ITEM: TENTATIVE SKETCH PLAN - 21 Bala Avenue, Bala Cynwyd, Ward 9, LD# 3923TS

**SUBJECT:** TENTATIVE SKETCH PLAN – 19-21 Bala Avenue, Bala Cynwyd, LD# 3923TS

**Re: 19-21 Bala Avenue – Bala Lofts  
Tentative Sketch Plan Review**

Re: MCPC #24-0227-003  
Plan Name: 19 & 21 Bala Avenue  
(33 du and 1,800 sq. ft. commercial on approximately 0.69 acres)  
Situate: Bala Avenue (E); south of Union Avenue  
Lower Merion Township

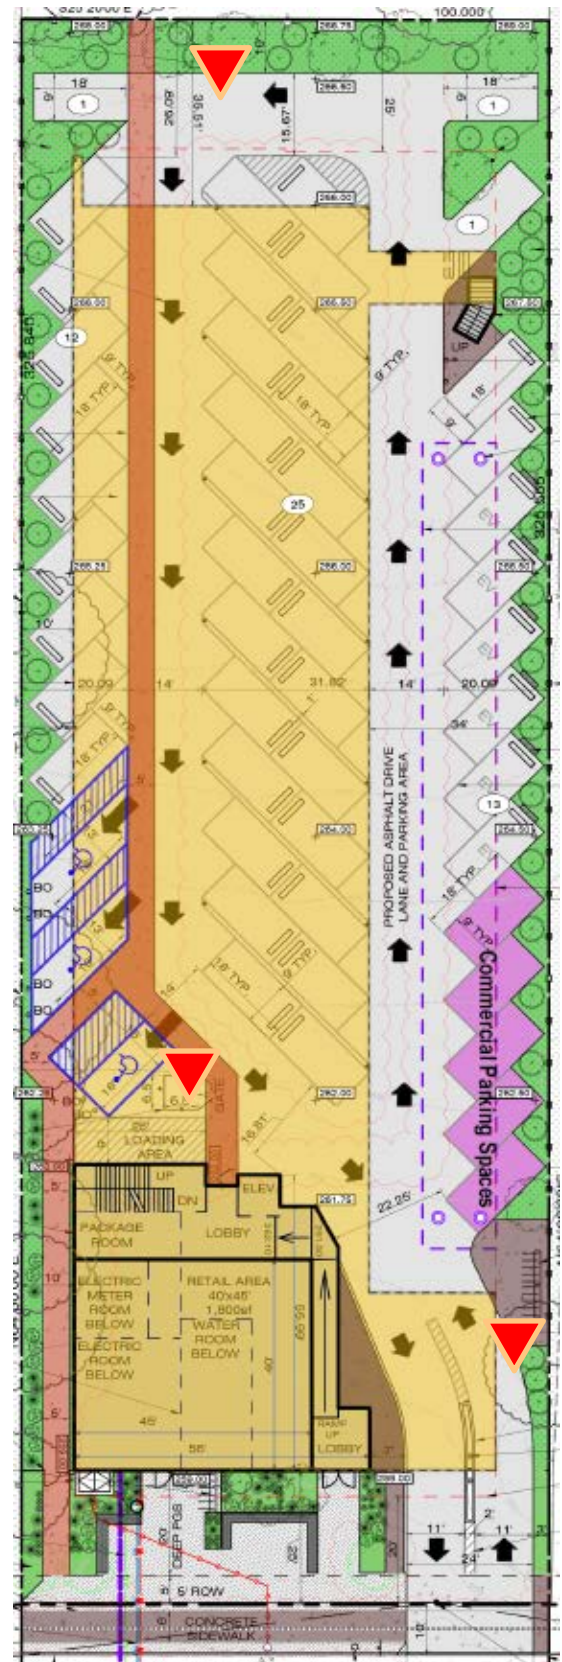
The Applicant has requested a waiver from Subdivision and Land Development Ordinance §135-4.9(Q)(7) which requires a pedestrian pathway through a surface parking lot with 10 or more parking spaces to be clearly separated from vehicular use areas.

The proposed parking lot is a surface lot with 53 spaces shown on plans at grade level with 37 spaces underneath or partially beneath the columned upper stories of the structure.

The Applicant proposes to provide the required pedestrian pathway within the drive aisle. As required, the pathway will be delineated by a change of material. Plans show the pathway material will be concrete. Additionally, plans show several pedestrian yield signs and bollards.

While a material change serves to delineate a pathway, it will not clearly separate pedestrians from vehicles as required by Code §135-4.9(Q)(7) which states that the pathway “be physically delineated and provided through the installation of sidewalks and defined crosswalks.”

# Consideration 1

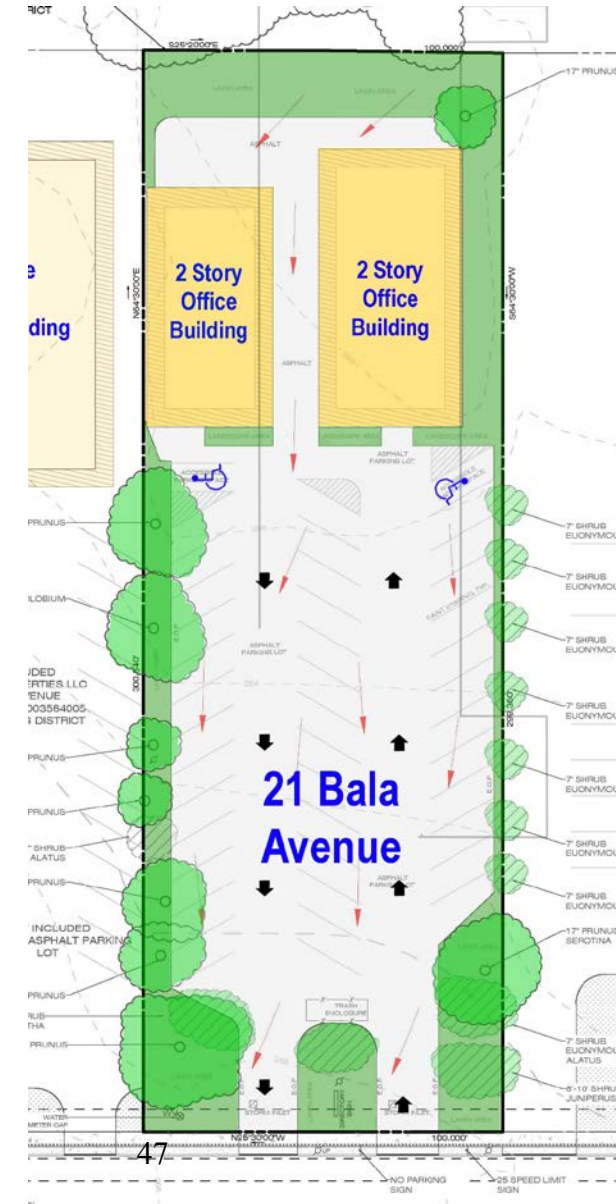
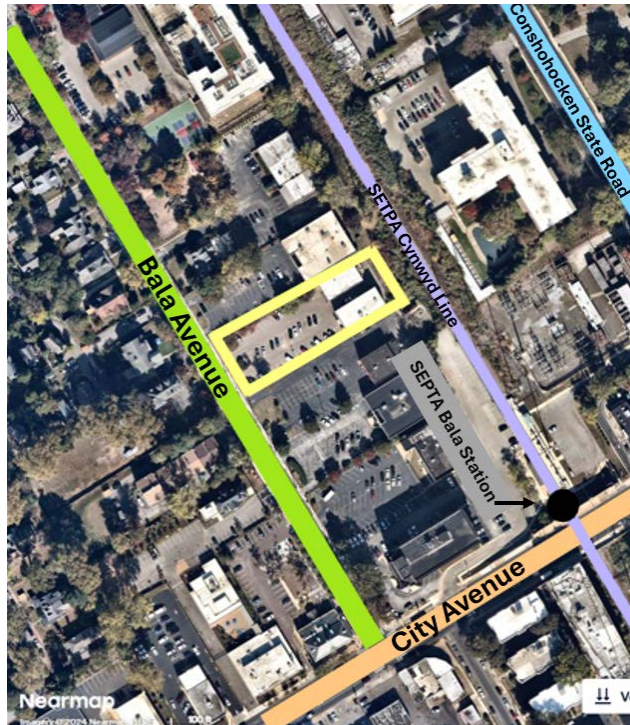
Connect the pedestrian pathway to the commercial parking spaces.

Add a pedestrian pathway to connect to commercial parking
